Access Compliance Report
Public Rights-of-Way
(Pedestrian Signals)

cole   **CHARLOTTE**

ADA ID: A7CB7A8CBC34   **Signal Type:** One Push Button-Non APS   **Overall Compliance:** No   **Severity Score: BTN 1:** N/A   **BTN 2:** N/A   **No BTN:** N/A

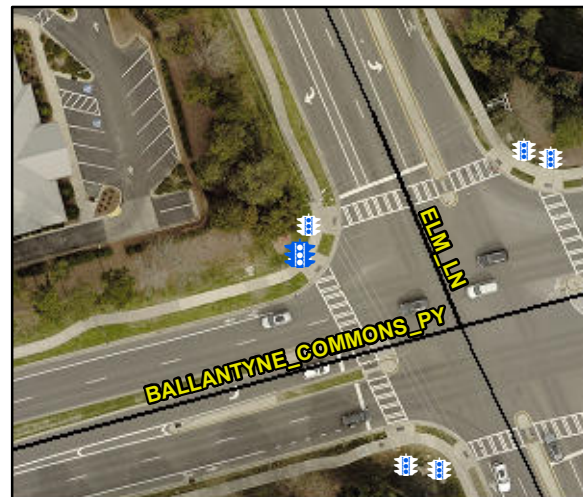
PROW/ADA: TMUTCD 4e.08, R404.2

Possible Solutions: Replace Signal Push Button With APS Button on New Post. Remove & Relocate Sign.
